OFFICE OF PLANNING  
AND ENGINEERING

December 4, 2017

**Re: Robsham Village – Application for Comprehensive Permit (40B)**

## Sight Distance Graphic

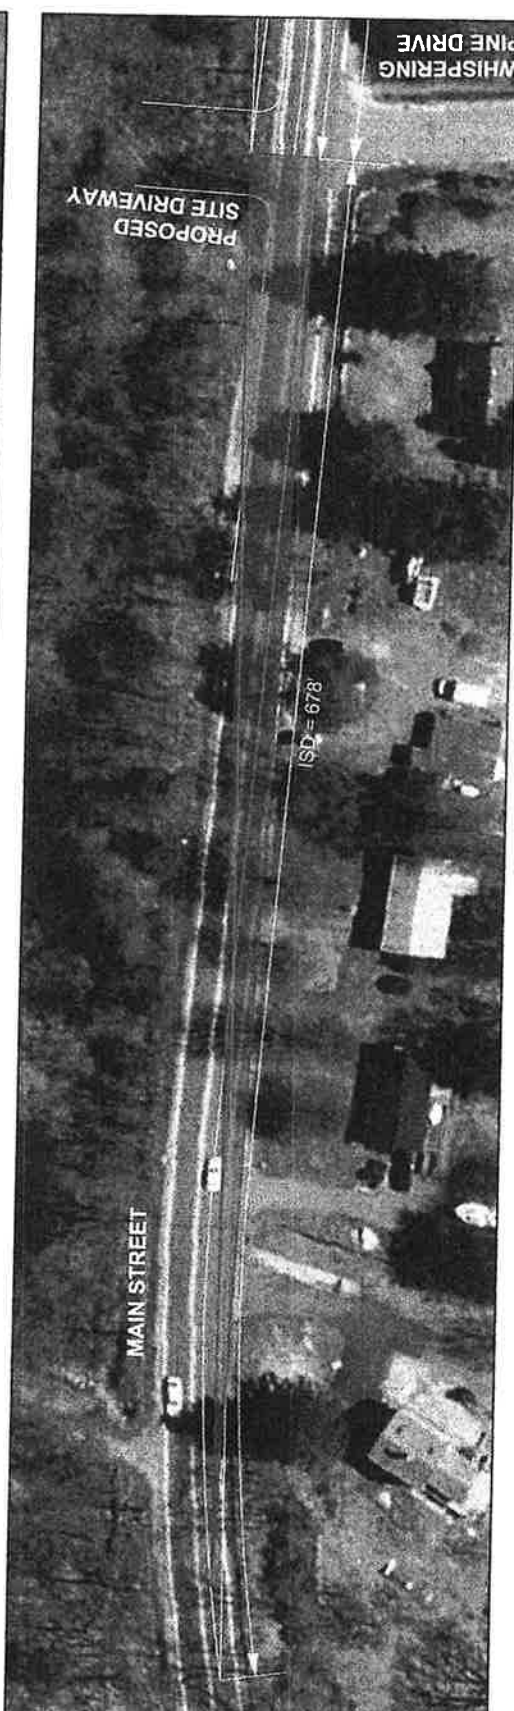
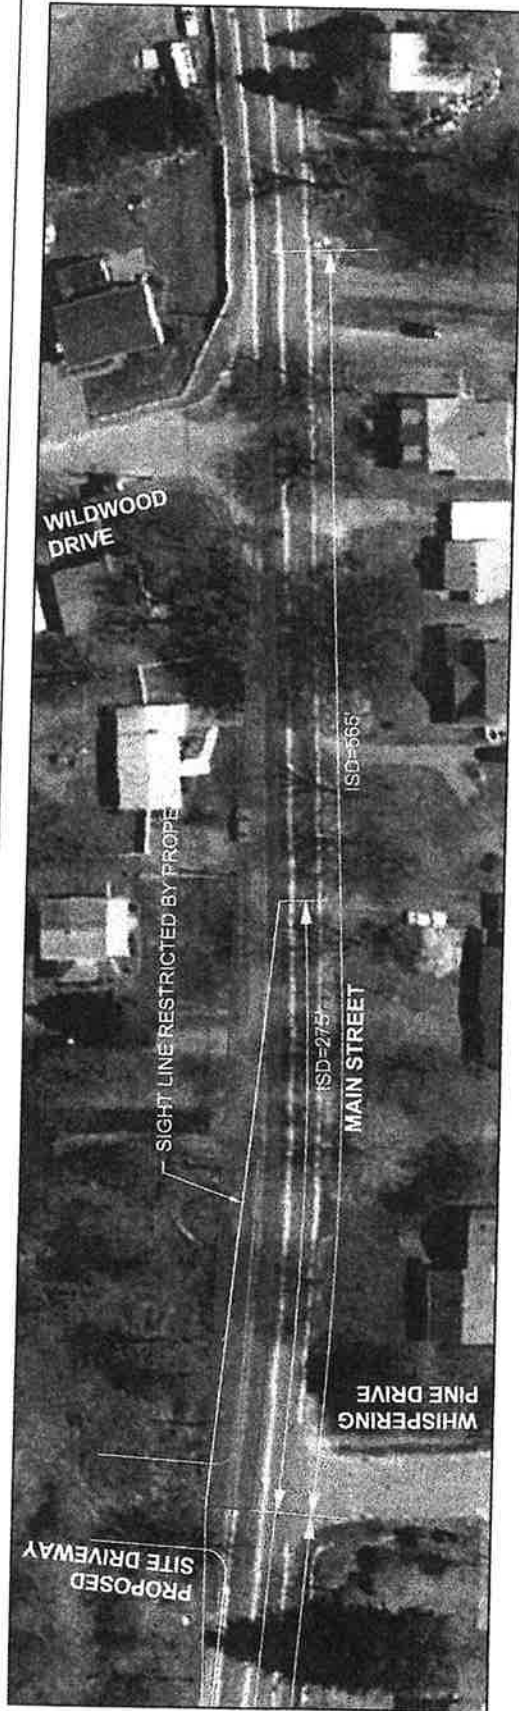
1. The Traffic Impact and Access Study, more specifically, Sight Distance Analysis, Table 6 and Sight Distance Graphic. The information does not clearly indicate that there is adequate sight distance available at the proposed Access Drive and East Main Street (Route 16). Table 6 includes a footnote "b", which states "*ISD Measurement is approximate, estimated based on reviewing aerial images and record plans when existing vegetation along the site frontage is cleared. The 560' sight line looking left out of the site traverses the adjacent property*". There are distances, under the "measured" column (of Table 6) that show measurements of 700', there is no sight distance looking left out of the new access drive that measures 700' (See Exhibit A).

It is unclear what the actual sight distances are at the proposed access drive. Without knowing what the sight distance is, it is not clear that this new intersection is safe. This was one of my major concerns during my initial review of the project in July, 2016 and still appears to have not been clearly addressed. This is a safety concern.
